This document was generated in response to a request from Frank Coperich for additional technical information in regards to the Part22 type approval of the QSec 800 (fcc ID: J9CQSEC800). This document includes the email received by Mr. Coperich and the response to each question.

Re: FCC ID J9CQSEC800
Applicant: Qualcomm Incorporated
Correspondence Reference Number: 15567
731 Confirmation Number: EA98117
Date of Original E-Mail: 08/11/2000

SN#41 Right Head, Channel 991, 8-14-00

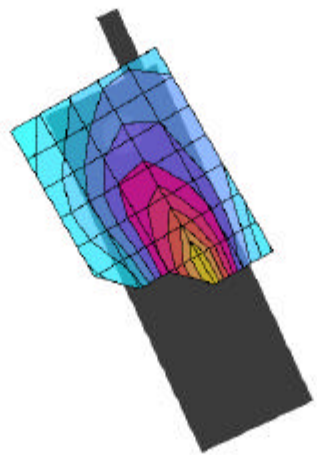
1. Right side head SAR plots have been clipped and do not include the entire peak SAR locations on those plots. Please clarify and repeat the SAR measurement if necessary. Note: DASY system has updated software that allows scanning in low cheek and jaw regions of that phantom.

The SAR plots were clipped due to an incorrect software parameter for the graphical results. The right head SAR, however, was re-tested with the correct parameters, and the results can be found at the end of the section. The DASY system is scheduled for a software upgrade in the near future to accommodate future filings.
